# THE GIBSON

A NEW FREMONT RESIDENTIAL  
APARTMENT BUILDING

3421 & 3422 WOODLAND PARK  
AVE N, SEATTLE WA  
3032609-EG

RECOMMENDATION  
DRAFT

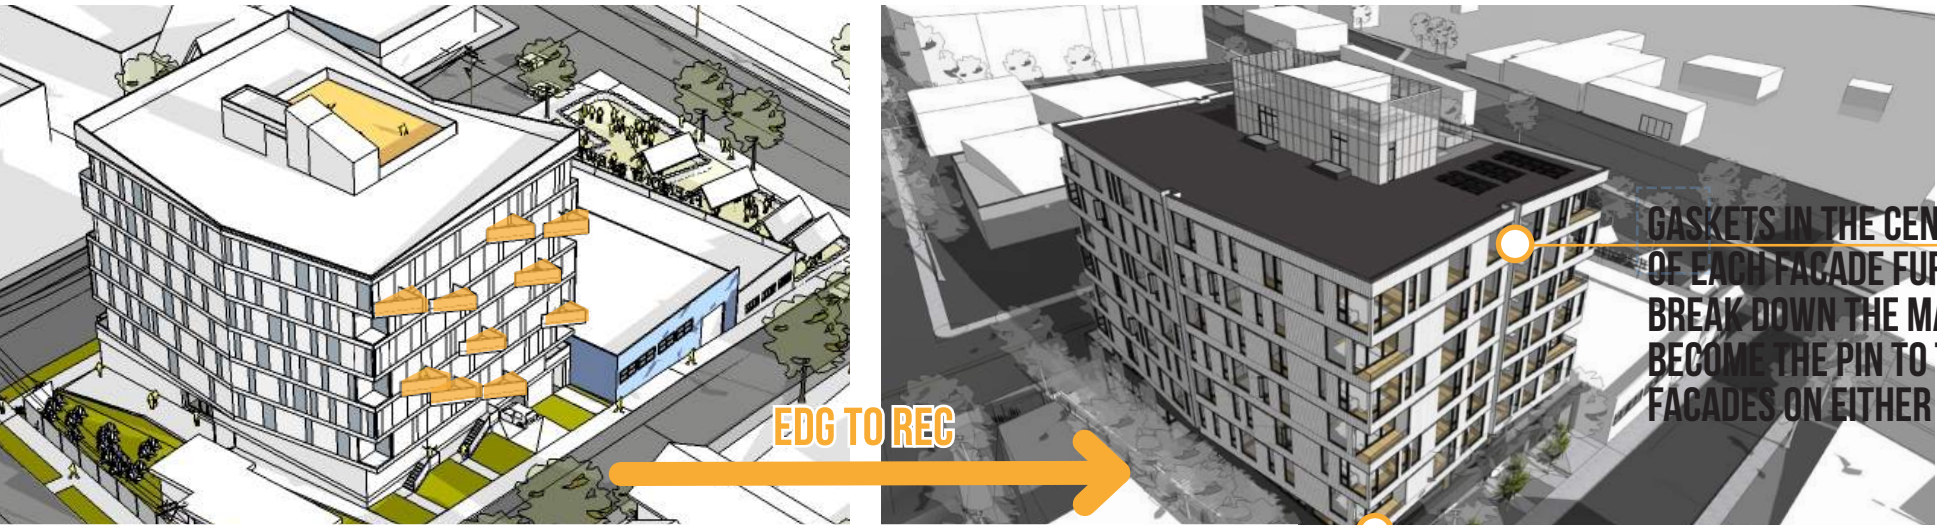
The board suggested further studies and **additions of recessed balconies** to gain advantage of the views. The board questioned the usability of the balconies on the west facade due to the size.

- a. In response to public comment, the Board directed further study of additional recessed balconies on the south facade in a manner that activates and enlivens the façade, takes advantage of views, and is consistent with the eroded corners concept. Studies should be documented at the Recommendation phase. (DC2, DC2-A-1, DC2B-1, DC2-C-1, DC2-C-2)
- b. The Board noted that the attached balconies on the west façade successfully contribute to a quirky character; however, the Board noted the balconies should be of a useable size. (CS3, DC2, DC2-C, DC3-B-1)

- a. In response to design guidance, the design team investigated approaches to further activate the south facade. Recessed balconies were staggered, similarly to the eroded corners to provide variety and visual interest while breaking up the building facade to decrease the visual weight of the mass. This integration allows opportunity for exterior living space for some units and access towards the Lake Union views.
- b. There were several limitations, including balcony functional size, which limited the use of the triangular balconies. The proposed design, thus eliminates this option in lieu of a more wholistic and continuous approach including the recessed balconies at the corner. Recessing the balconies into the building mass allows additional weather protection for use year round.

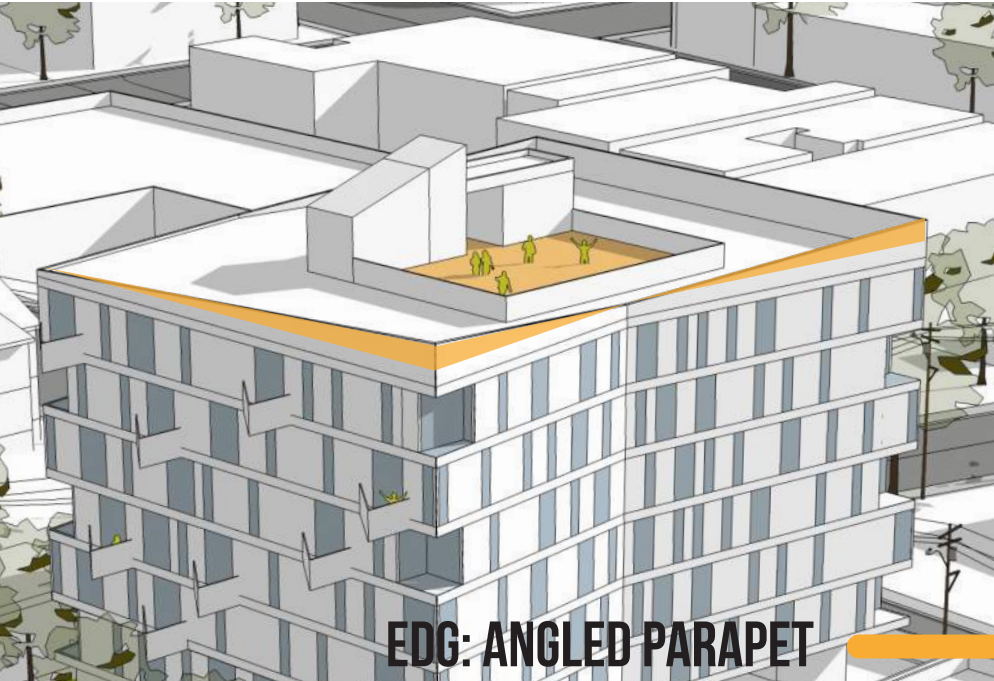
C. In agreement with public comment, the Board supported the continuous horizontal banding. The Board noted that banding should be achieved through figure/ground composition of glazing and materials, as depicted in precedent images 1 and 3 on page 35 of the EDG Packet, rather than literal horizontal material striping, as depicted in precedent image 4 on the same page. (DC2-B-1)

Response: As the design developed, the design team followed guidance to provide for a continuous horizontal design language as emphasized below on the podium and through the banding in the main white metal mass. While the darker base materials weight and ground the building, the dark windows were picked up at the top to compose the fenestration within the figure / ground methodology proposed, helping break up and further define the window openings.

The vertical expression of the proposed metal panel both at the base (dark metal panel) and at the upper mass of the building (proposed in white metal paneling) relates to the precedent images as presented here and design cues are implemented from the window patterns, particularly at image 3. A horizontal flashing join along the top of each floor brings an honesty to both the material but also to the structural identity of the floor plate behind it. This move further emphasizes the continuous horizontal banding

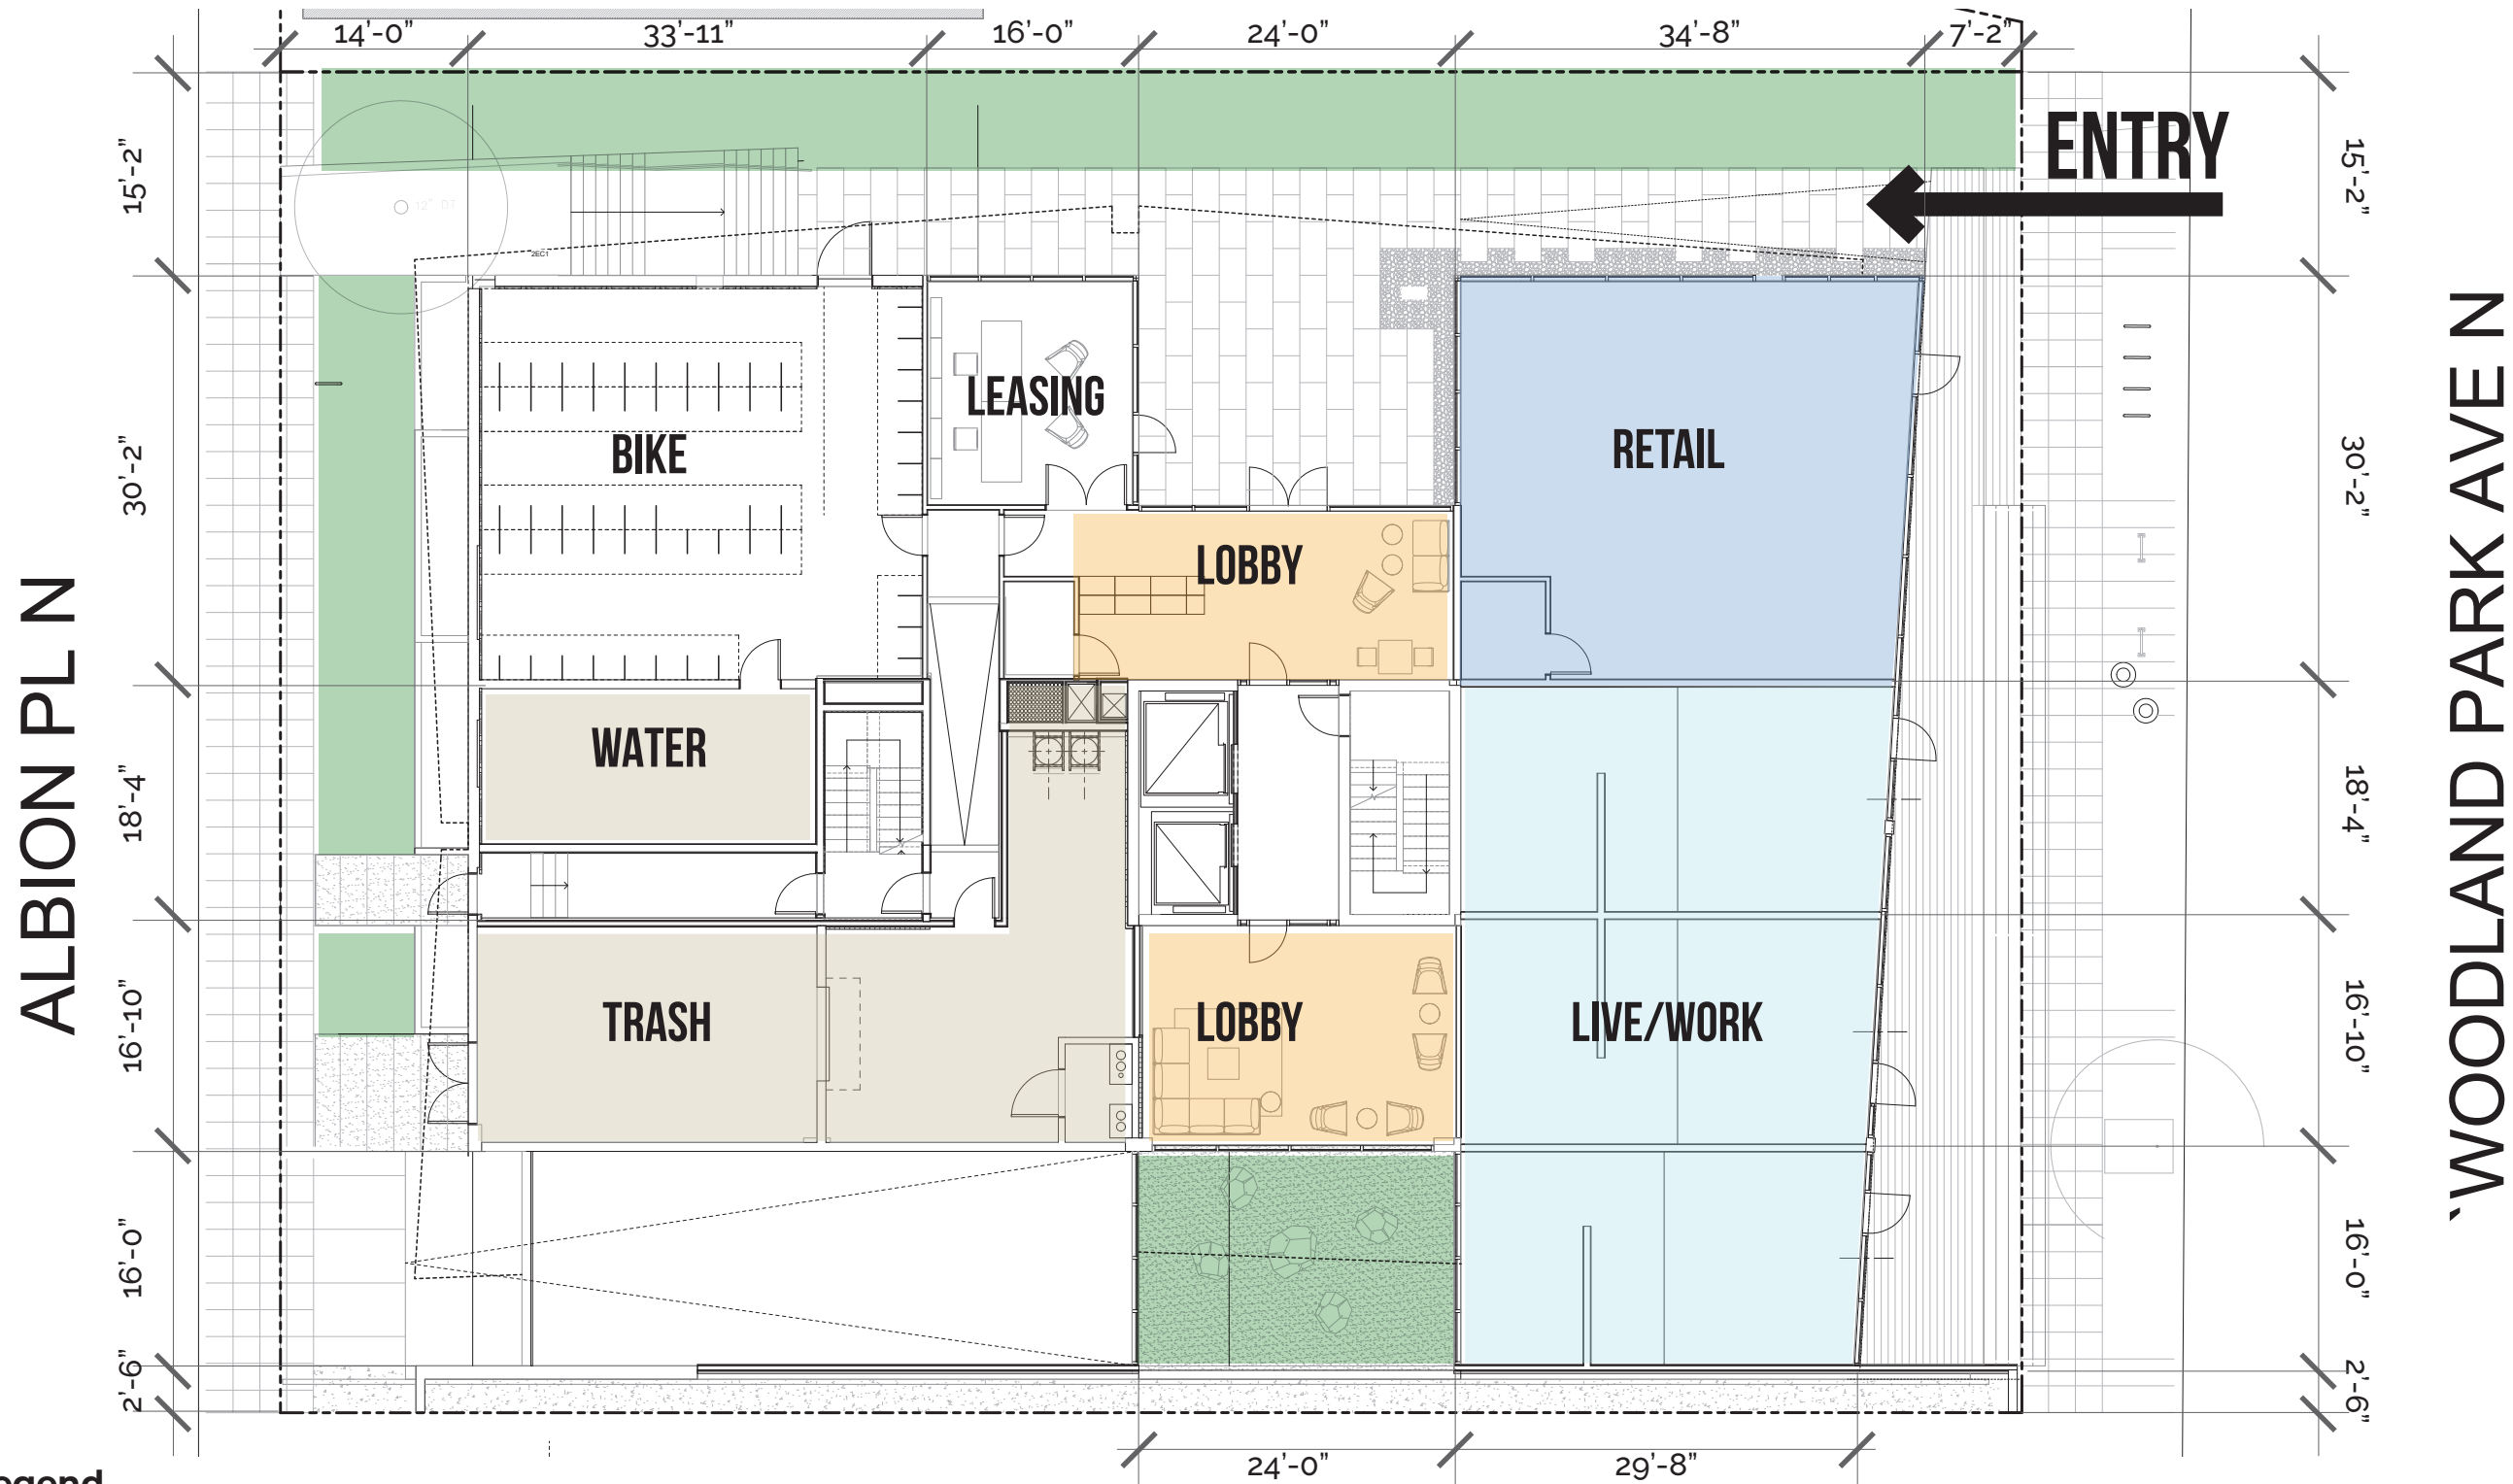
The board supported the location of the amenity space and suggested that the penthouse should be designed to be sculptural. The board encouraged the incorporation of existing vegetation where possible.

- a. The Board supported the proposed location of the rooftop amenity on the south side of the penthouse - away from the less intense residential zones - as it promotes respect for adjacent sites. (CS2-D-5, DC3-B)
- b. In response to public comment, the Board noted that the rooftop will be perceived as a fifth elevation from the bridge and higher elevations. The penthouse should be designed to be sculptural, informed by the overall architectural concept and inspired by the character of the Fremont neighborhood. (CS3-A, DC2, DC2-B-1, DC3)
- c. The Board encouraged the incorporation of existing vegetation where possible, and directed further consideration of conifers in the landscape design. The Board specifically prioritized Design Guideline DC4-D, Trees, Landscape and Hardscape Materials. (DC4-D)
